Wiring Instructions for Dryer Timer

NOTE: This instruction sheet provides special wiring instructions for applications when timer 3398190 is used in place of timer 3391658. When replacing 3391658 with the 3398190, follow instructions below carefully. Otherwise, reconnect wire leads in the same manner as they were removed.

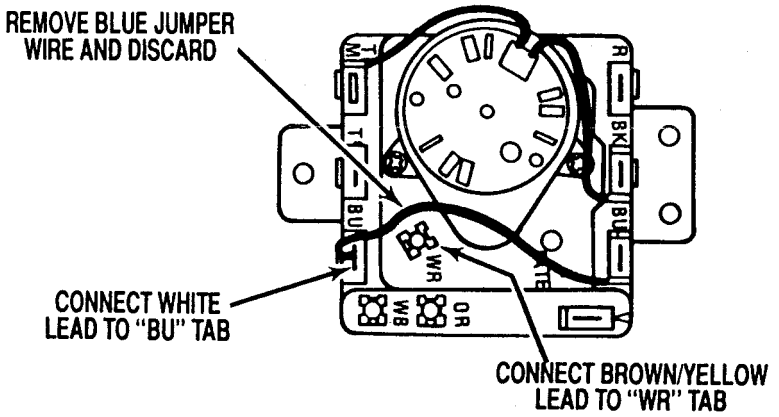
Replace 3391658 as follows: (Reference illustration below)

1. Remove blue jumper wire and discard.
2. Connect white lead to single "BU" tab next to "T."
3. Connect brown/yellow lead to "WR" tab.
4. Connect remaining wire leads in the same manner as they were removed.
